LARAMIE COUNTY PLANNING & DEVELOPMENT DEPARTMENT

TITLE: PUBLIC HEARING regarding a Subdivision Permit and Plat for J BAR L Subdivision, for a portion of the NW1/4 SE1/4 Section 24, T.15N., R.65W., of the 6th P.M., Laramie County, WY..

PZ-21-00058(59)

I hope this addresses the concerns brought out in the staff reports and allows the J Bar L subdivision to go forward.

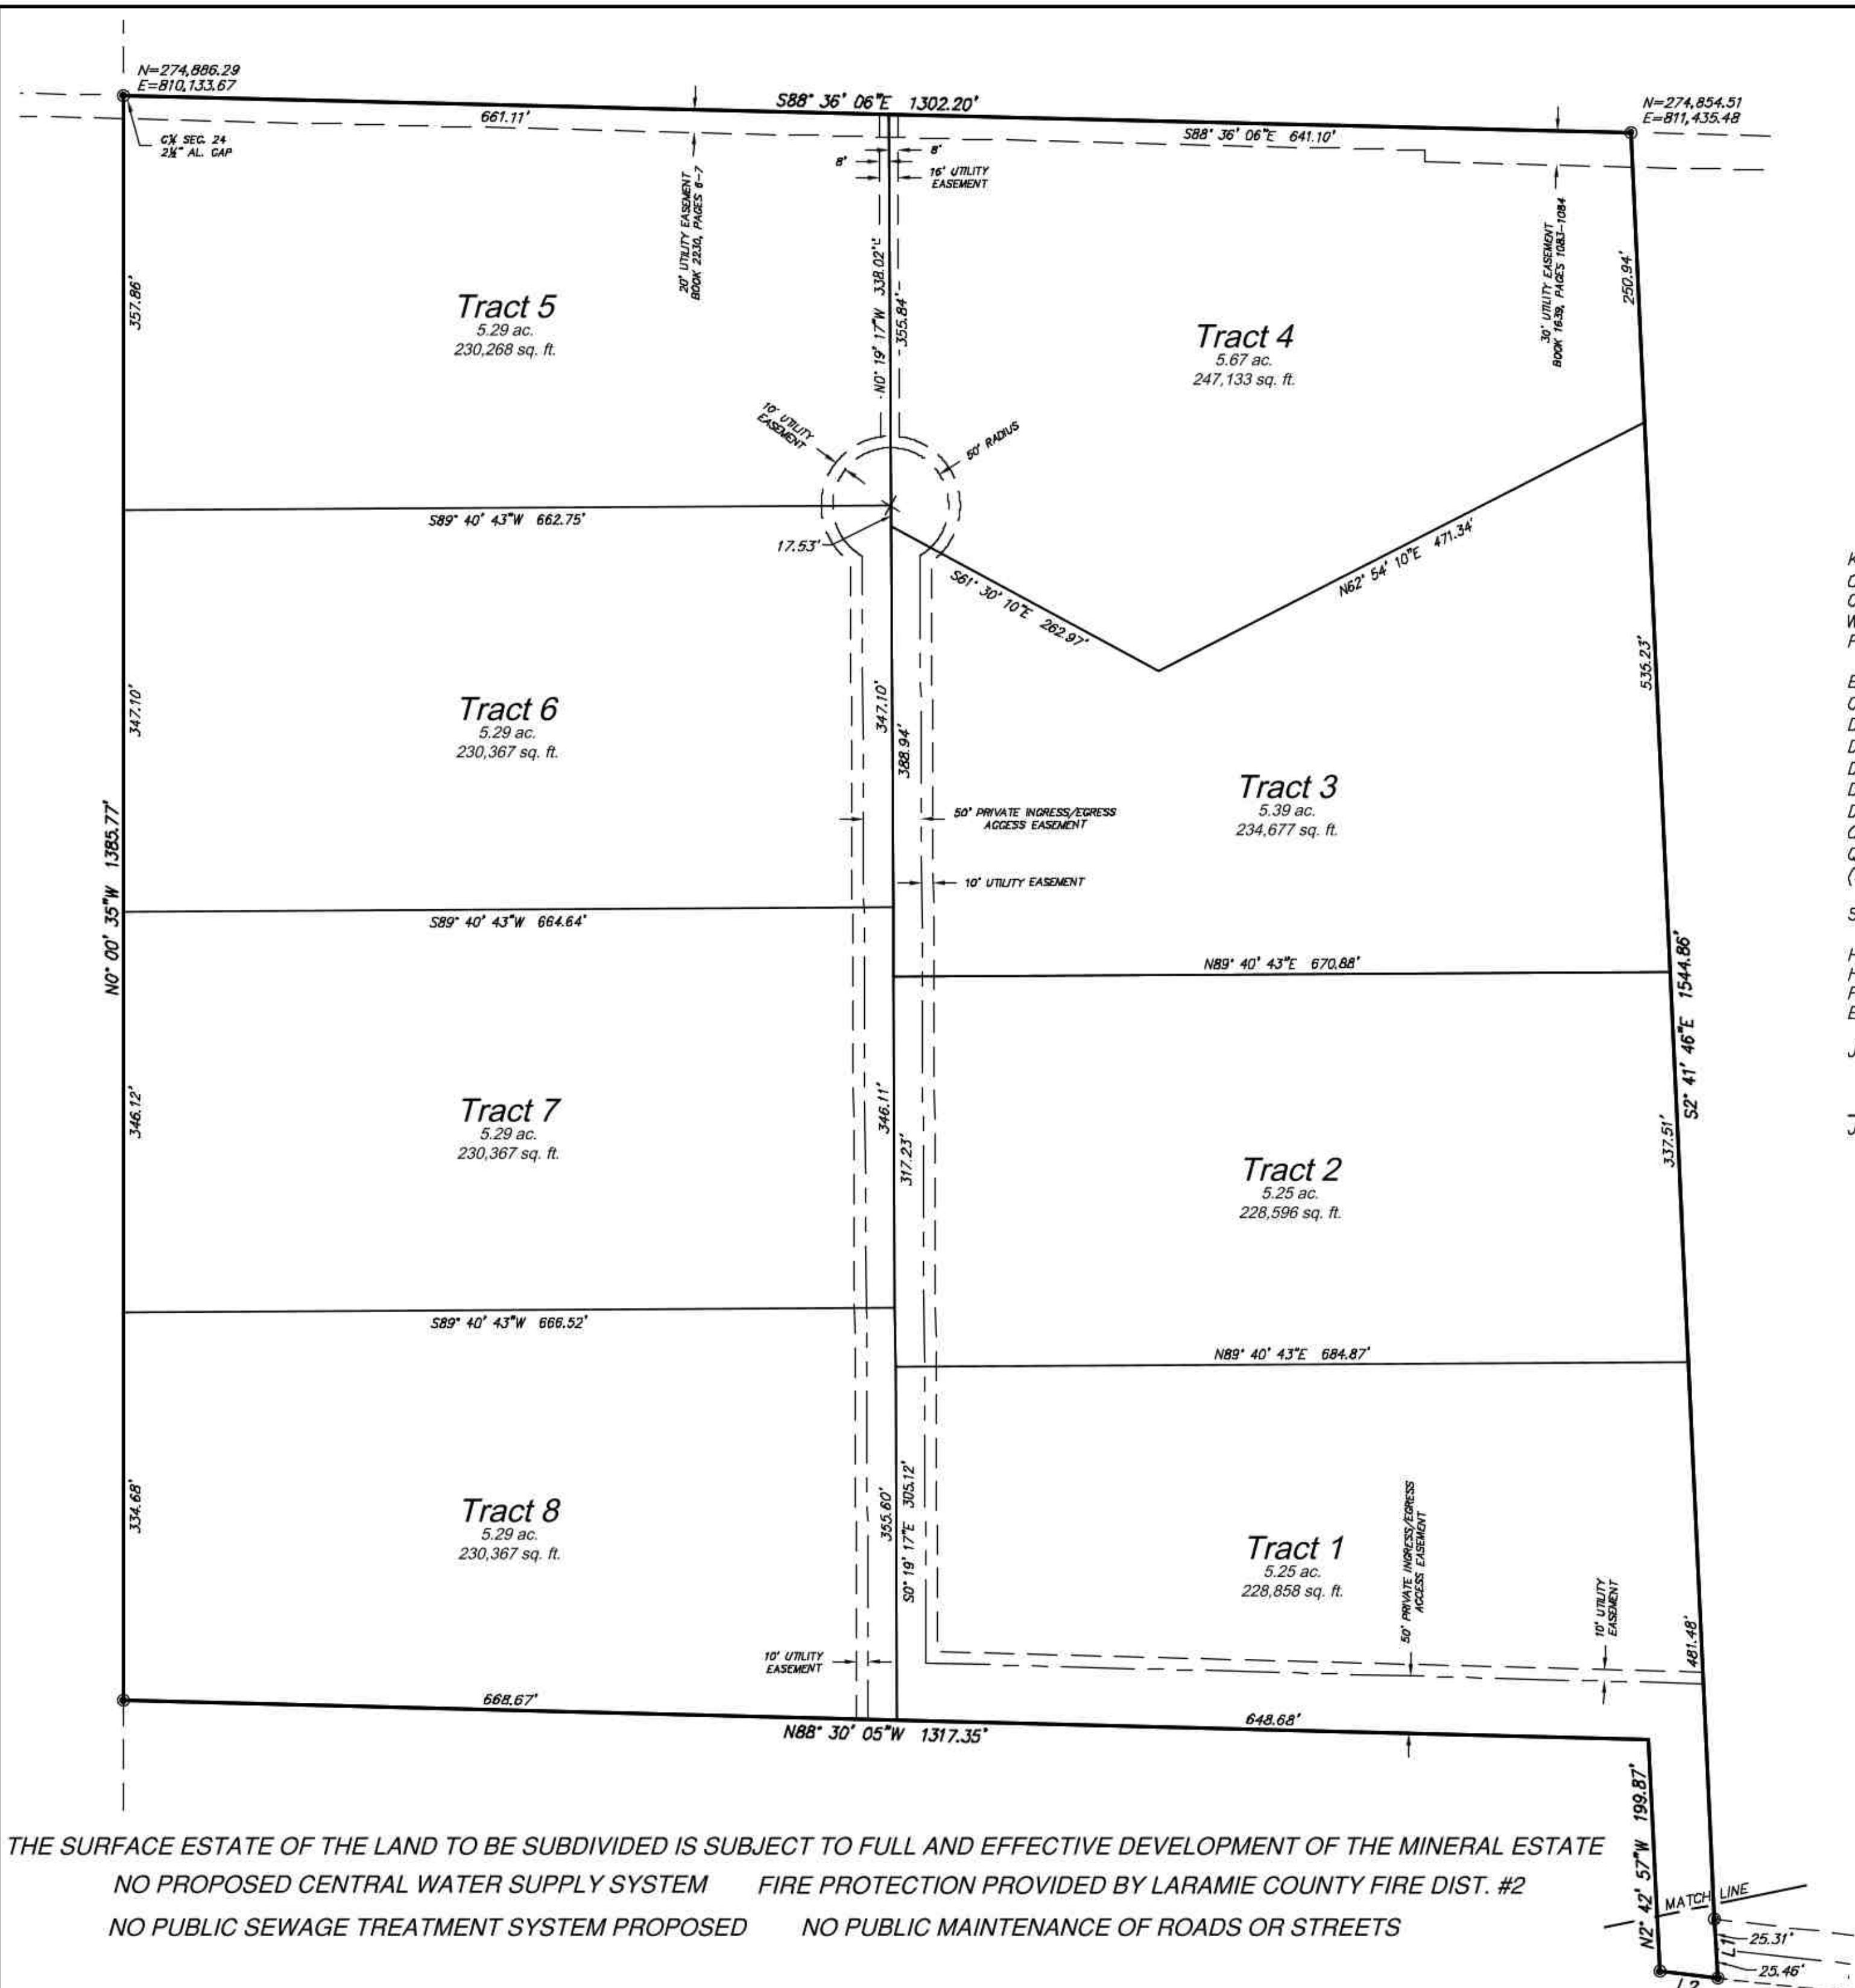
County Assessor: County Assessor, Kaycee Eisele Comments Attached 03/10/2021
APPROVALS AREA, DATE IS STILL MARKED 2020.

County Attorney: County Attorney, Joe Chenchar Comments Attached 03/23/2021
Our office has concerns regarding the access to the property. First, the easement does not clearly identify a dominant estate owner. Second, it is unclear whether the easement effectively transferred to the current owner, or if it will transfer given the proposed subdivision of land. Third, the expected increase in daily traffic has the potential to increase the burden on the servient land.

County Engineer: County Engineer, Scott Larson Comments Attached 03/23/2021
PZ-21-00059 -- J BAR L Subdivision -- Subdivision Permit/Plat Review
Engineer Review

1. The year listed under the Approvals are both shown as 2020 which should actually be 2021.
2. I concur with the request for a waiver of a detailed Traffic Study and Drainage Study since this development will have a negligible impact on both.
3. The roadway from CR136 to the end of the cul-de-sac shall be designed and constructed to meet the current LCLUR. The designs shall be submitted to the County for review and approval.

1. The exact location and specifications for the 50' radius curve of the INGRESS/EGRESS ACCESS EASEMENT located in the southwest corner of Tract 1 and the exact location and specifications for the CUL-DE-SAC located at the north end of the INGRESS/EGRESS ACCESS EASEMENT are not completely identified as specified in this section of the regulations.
2. With respect to the 50' INGRESS/ACCESS & UTILITY EASEMENT shown as recorded in Book 1587 on Page 1003, it would be good to include the survey tie to the Southeast Corner of Section 24.
3. Should the 50' INGRESS/EGRESS ACCESS EASEMENTS have road names?
4. Some of the text is pretty small and difficult to read.

1. Are the tract acreages net or gross? I assume they're net due to Note 4, but it is not clear.
2. The vicinity map is not legible.
3. Approval dates must be updated to 2021.
4. See Engineer/Surveyor's comments regarding missing cul-de-sac and radius details. These, along with a curve table, must be shown on the plat per 2-1-101 (e)(xiii)(b).
5. County Road 136 needs to be labeled as just Road 136.

REV. 04/28/21
REV. 04/16/21
REV. 03/25/21
